SUBJECT: WATERFORD STEAM ELECTRIC STATION, UNIT 3 – REQUEST FOR
ALTERNATIVE W3-ISI-015, INSPECTION OF REACTOR VESSEL HEAD
IN-CORE INSTRUMENT NOZZLES DURING THIRD 10-YEAR INSERVICE
INSPECTION INTERVAL (TAC NO. ME2401)

SAFETY EVALUATION BY THE OFFICE OF NUCLEAR REACTOR REGULATION

REQUEST FOR ALTERNATIVE W3-ISI-015

WATERFORD STEAM ELECTRIC STATION, UNIT 3

conditions specified in paragraphs (g)(6)(ii)(D)(2) through (6). The licensee is to perform a volumetric and/or surface examination of essentially 100 percent of the required volume or equivalent surfaces of the nozzle tube, as identified by Fig. 2 (shown below) of ASME Code Case N-729-1.

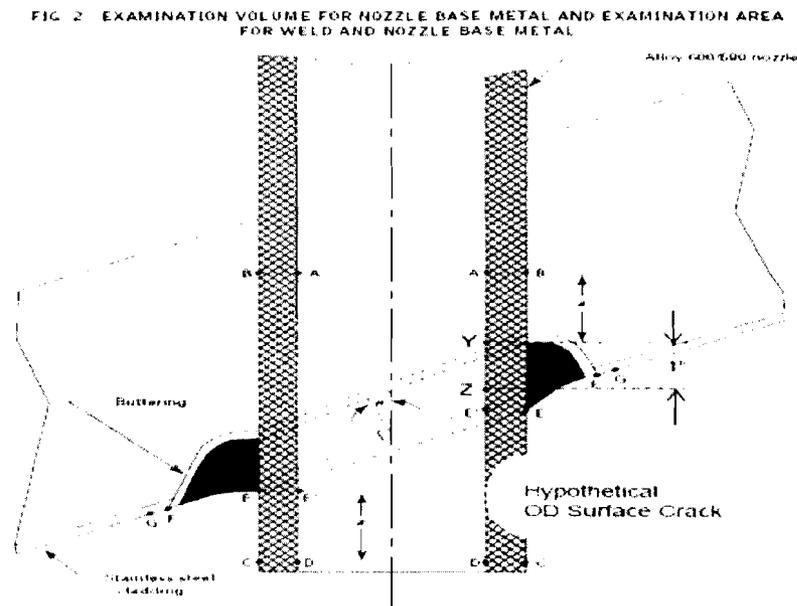
Fig. 2 of ASME Code Case N-729-1 identifies the required volume of tube to be inspected as a distance "a" above the highest point of the root (Y) of the J-groove weld to a distance "a" below the lowest point of the toe (E) of the J-groove weld. The distance "a" is equal to 1.5 inches (38 millimeters or mm) for incidence angle, Θ , ≤ 30 degrees and for all nozzles ≥ 4.5 inches (115 mm) outside diameter (OD) or 1 inches (25 mm) for incidence angle, Θ , ≥ 30 degrees; or to the end of the tube, whichever is less. Since the ICI nozzle tubes have an OD of 5.563 inches, the required distance "a" is 1.5 inches. If a surface examination is being substituted for a volumetric examination on a portion of a penetrating nozzle that is below the toe of the J-groove weld, the surface examination shall be of the inside and outside wetted surface of the penetration nozzle not examined volumetrically (A-D-C-E).

Referring to Fig. 2, the licensee proposes to perform an eddy current (ET) examination of the ID (A-D) and bottom surfaces (C-D) of the nozzle tube. The ET examination will extend from a distance "a" above the highest point of the J-groove weld root (Y) to the extent possible below the J-groove weld, and include the bottom surface of the penetration nozzle tube. Instead of the ET examination of the nozzle tube OD surface (C-E), the licensee proposes to perform a volumetric examination of the nozzle tube on the ID from 1.5 inches above the J-groove weld root to detectable extent of the nozzle tube below the J-groove weld (A-D) and on the lower end surface (C-D) using time of flight diffraction (TOFD) UT examination. Where the UT data quality between the J-groove weld root to one inch below the J-groove weld root (Y-Z) is determined to be unacceptable, a compensatory ET examination of the ICI nozzle tube outside diameter (OD) surface (C-E) will be performed.

The NRC staff notes that axial through-wall cracks and axial ID surface cracks do not need to be considered further in the flaw growth analysis since the ASME Code-compliant ET examination of the ID surface (A-D) will ensure that no surface penetrating cracks exceeding Code limits exist on the ID surface. Also, OD surface cracks above the J-groove weld do not need to be considered because they cannot be initiated in the absence of primary water, and the existence of primary water in the OD region above the J-groove weld is evaluated by the required bare metal visual inspection of the head and the qualified weld leak path assessment.

The bounding condition for a hypothetical axial crack that is not examined by an ASME Code-compliant technique and could exist in contact with primary water is a surface crack on the nozzle tube OD below the J-groove weld whose crack depth (a) approaches the wall thickness (t) at time of ET examination ID inspection (i.e., the value of a/t approaches one). The uppermost extent that such a hypothetical crack on the nozzle tube could exist is determined by the supplemental TOFD UT examination from the ID surface. The licensee's requirement of a minimum of 1 inch of acceptable UT data below the J-groove weld root ensures that a crack cannot exist in this inspected volume. The NRC staff notes that although the UT examination is not compliant with the qualification requirements of 10 CFR 50.55a(g)(6)(ii)(D)(4), the operators and procedures have been qualified for control element drive mechanism nozzle tube examinations, and UT examination has been accepted for ICI nozzle examination under the Order. Therefore, the staff concludes that the examination provides reasonable assurance that an OD surface flaw does not exist within the specified 1-inch distance to the J-groove weld root.

After a small increment in operating time, such an OD surface crack could become a through-wall crack and begin to propagate in the axial direction. The licensee has analyzed the time required for a through-wall crack whose upper tip is located 1 inch below the root of the J-groove weld (Z) to propagate to the root (Y) of the J-groove weld. The NRC staff has evaluated the licensee's fracture mechanics crack growth data for this condition (Reference 4, Figures 6-10A and 6-11A) and determined that the minimum time for such a through-wall crack to propagate to the root of the J-groove weld is in excess of 2.6 years, a time period greater than that of one operating cycle. The NRC staff, therefore, concludes that there is sufficient margin to ensure pressure boundary integrity of the ICI nozzles for one cycle of operation.
